In the Matter of)
)
CAROLINA POWER & LIGHT COMPANY)
AND NORTH CAROLINA EASTERN MUNICIPAL) Docket Nos. 50-400 OL
POWER AGENCY) 50-401 OL
(Shearon Harris Nuclear Power Plant,)
Units 1 & 2))

APPLICANTS' RESPONSES TO RICHARD WILSON'S
INTERROGATORIES ON CONTENTION IVC (SECOND SET)

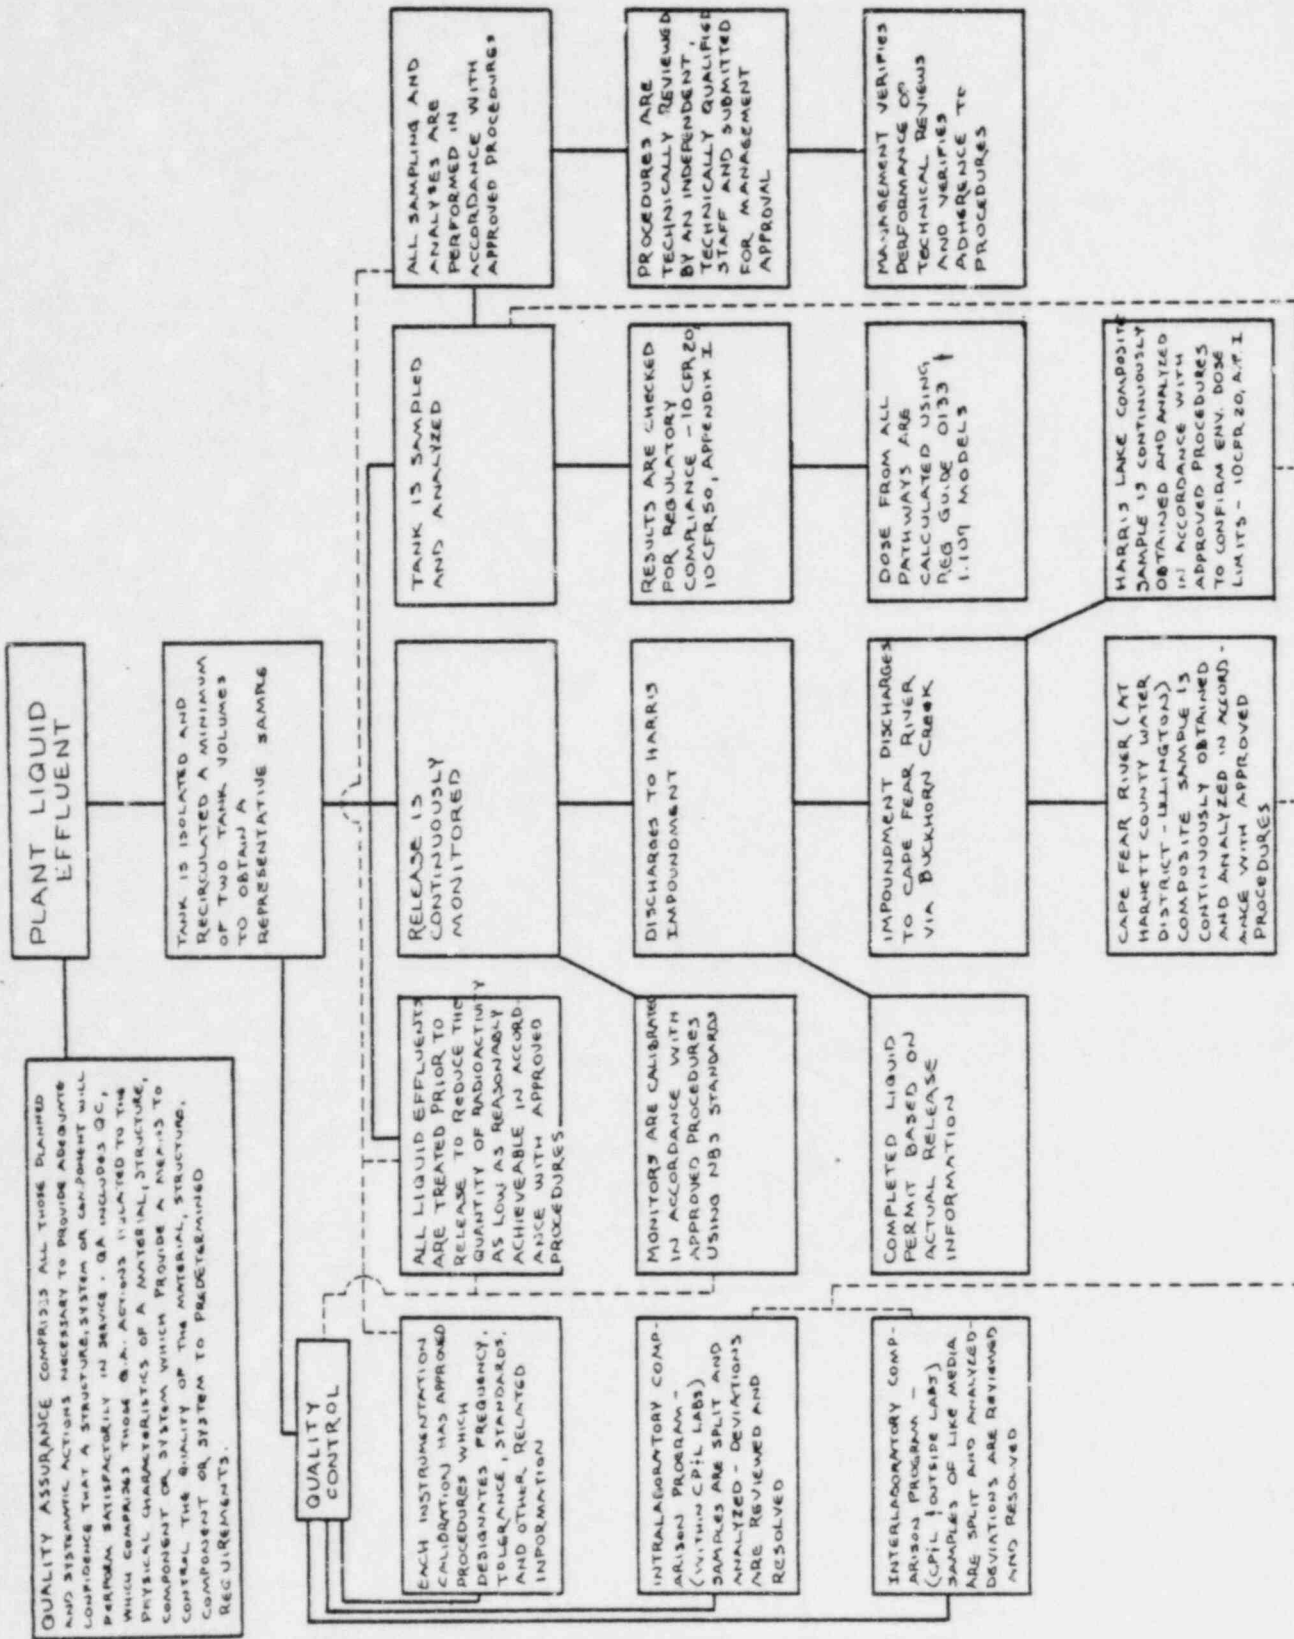
(4). Please illustrate a particular sampling pathway in detail, examining the precise method of control measurement, the systematic nature of sampling times, and the effects of inclement weather, etc. on the collection process.

ANSWER NO. IVC-2(4). See attached chart.

This chart was prepared by Don H. Edwards, Jr.; Senior Specialist - Environmental; Carolina Power & Light.
